Permit Application No.: 17-121

Applicant: **Minnehaha Creek Watershed District**

Project: **Minnehaha Preserve Enhancement Project**

Recommendation:

SHEET TITLE			
WETLAND BUFFER FIGURE			
DWN BY	CHK'D	APP'D	DWG DATE
MJS	CJM	MJS	JAN 2017
PROJECT NO.		SCALE	
0185-0027		AS SHOWN	
SHEET NO.			REV NO.
0			0

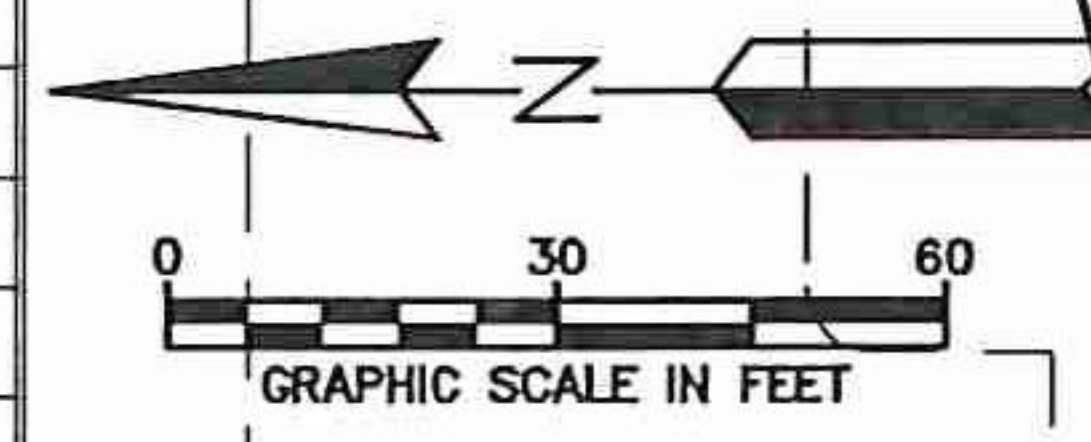
Monumentation of buffers with language required by paragraph 5 (d) is provided at the locations noted on the site plan included here as Attachment 4. Signs are located every 100 feet meeting the MCWD requirement.

The applicant has identified all available buffer space between the trail and the adjacent wetland, however, due to the location of the existing filtration BMPs and the location of the wetland complex, the applicant is unable to meet the minimum buffer width requirement or provide the total area of buffer required for either management class. The shortfall of buffer width and total buffer provided per MCWD buffer requirements is discussed in the exception section below.
